Application for Works Approval

Licence Number	W6223/2019/1
Applicant	Bunbury Harvey Regional Council
File Number	DER2018/001584
Premises	Stanley Road Class II Putrescible Landfill Site 51 Stanley Road WELLESLEY WA 6233 Lot 45 on Deposited Plan 17161 as depicted in Schedule 1 of the Works Approval
Date of Report	24 April 2020
Status of Report	Final

An application for Works Approval (Application) was received from Bunbury Harvey Regional Council (Applicant) to construct an enclosed tunnel composting facility and Green Waste mulching and storage area at Stanley Road Class II Putrescible Landfill Site (Premises). Table 2 summarises the prescribed activities related to this application.

Figure 3: Conceptual proposed design of hardstand outdoor areas

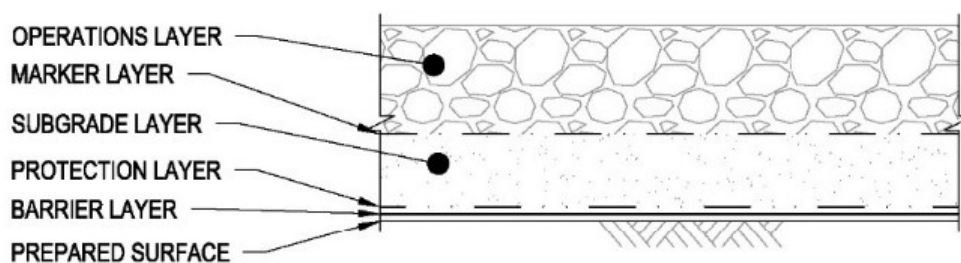
- The area of the pad where outdoor composting area will be undertaken (some 12,000 m² of the total 41,000 m² pad area) will have a HDPE liner (or equivalent barrier liner with a permeability of 1x10⁻¹¹ m/s or lower) placed beneath the gravel layer. This is to prevent compost affected stormwater from infiltrating into groundwater beneath the pad. Subject to detailed design, other materials may also be placed between the hard stand layer, and the barrier layer, as shown in Figure 3.

Figure 8: Acid sulfate soil risk at the Premises, with orange showing moderate to low risk and red showing high to moderate risk.

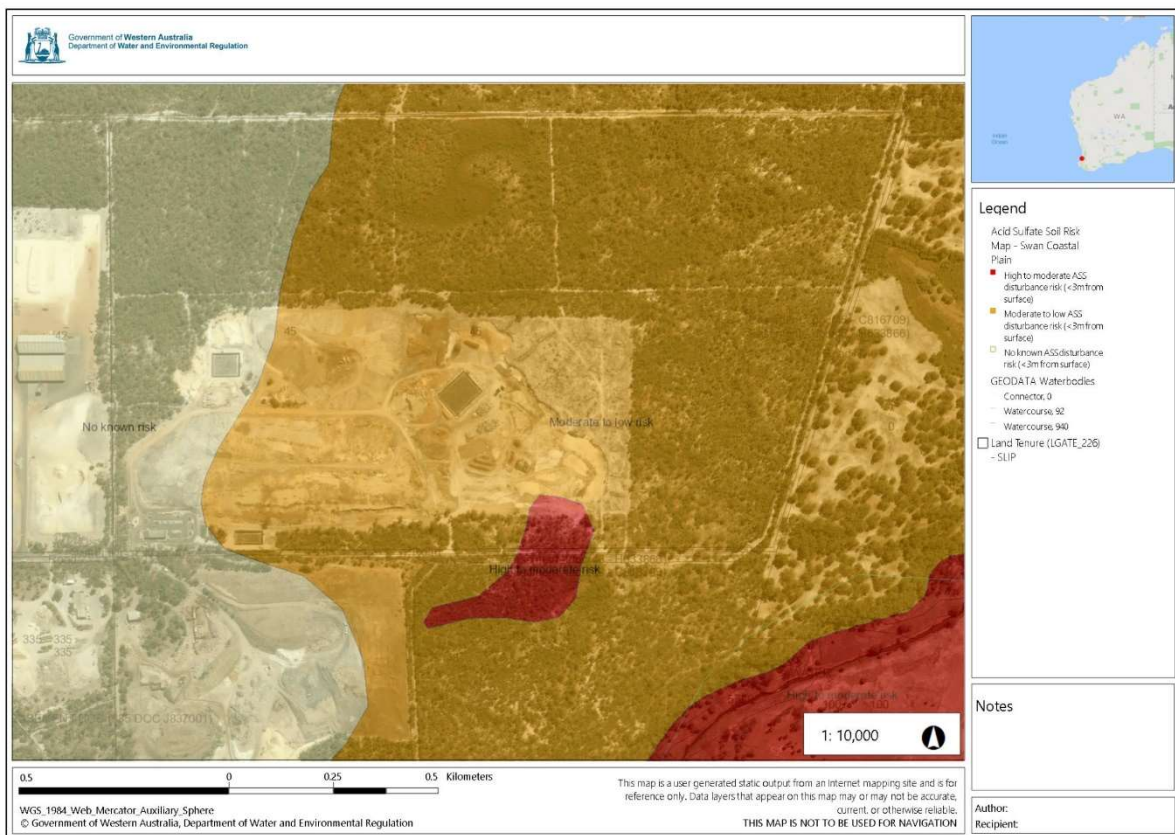
The works are planned in an area mapped as moderate to low risk for acid sulfate soils (ASS) (DWER Acid Sulfate Soil Risk Map - Swan Coastal Plan), and the southern end of the proposed cut area (GHD 2018, SK013 Concept Masterplan Cut and Fill Profile, Rev D November 2018) is approximately 100 m from an area considered high to moderate risk. There are wetlands within the northern part of the Premises and approximately 20 m from the southern Premises boundary. The submitted cut and fill quantity plan (GHD 2018) shows that excavations are proposed up to 5 m below the current ground level.

The Delegated Officer notes the following regarding acid sulfate soils; the proposed excavations for construction trigger the need to investigate acid sulfate soils to suitably identify the risk of ASS and prevent environmental harm under the EP Act. This is based on the DER (2013, amended 2015) guidelines, with proposed excavation in a mapped moderate to low risk area for ASS where it is:

- within 500 m of wetlands; and
- with earthworks extending to beyond 3 m below natural ground surface.

1. An acid sulfate soil investigation is required prior to these works being carried out. DER (2015) states that an acid sulfate soil investigation should be carried out where there is excavation within 500 m of a wetland and where there is planned excavation to greater than 3 m below the natural ground level in an area mapped as low to medium risk of acid sulfate soils.
